## SAFETY RECALL ACTION

<b>Reference number:</b>	RA-18-0026	<b>Issued: 18 December, 2017</b>
<b>Subject:</b>	Change to the Battery Supply Cable Routing	
<b>Model(s):</b>	DB9, DBS	
<b>VIN range:</b>	Refer to the separately published list of VINs	
<b>Applicable to:</b>	All US Dealers (Refer to VIN list).	
<b>Distribute to:</b>	After Sales Manager Executive Manager Service Manager Sales Manager	Warranty Technician(s) Parts

**Reason for this Safety Recall Action NHTSA ID: 17V795**

Figure 6

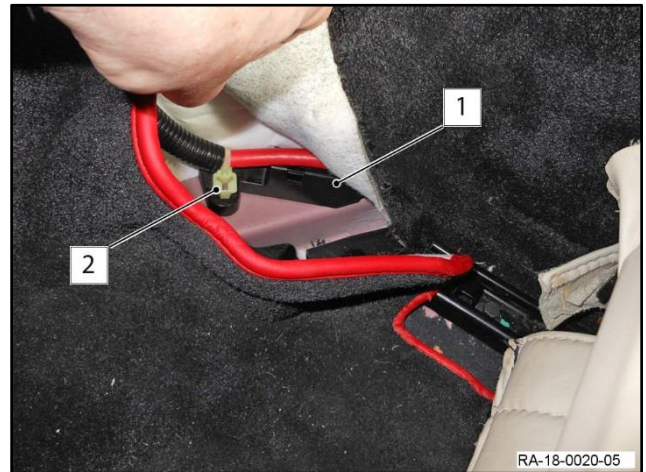
11. If the supply cable is not damaged, install the routing block.
- Install the block (1) on the weld stud.
  - Push the block against the body.
  - Push down the stud-mounted tie wrap (2) to attach the block (refer to Figure 6).

Figure 7

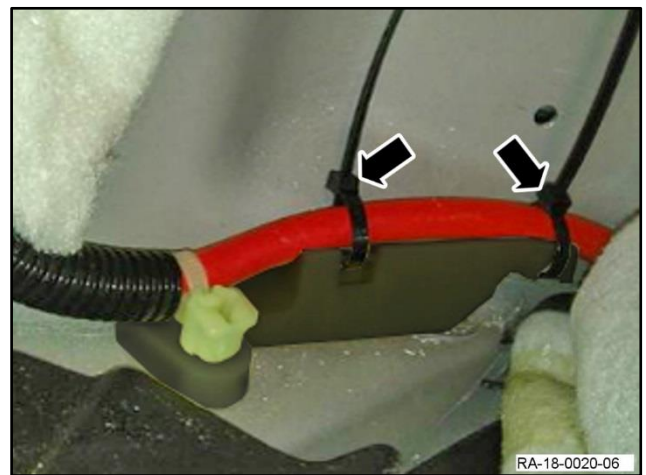
12. Use two cable ties to attach the supply cable to the routing block (refer to Figure 7).
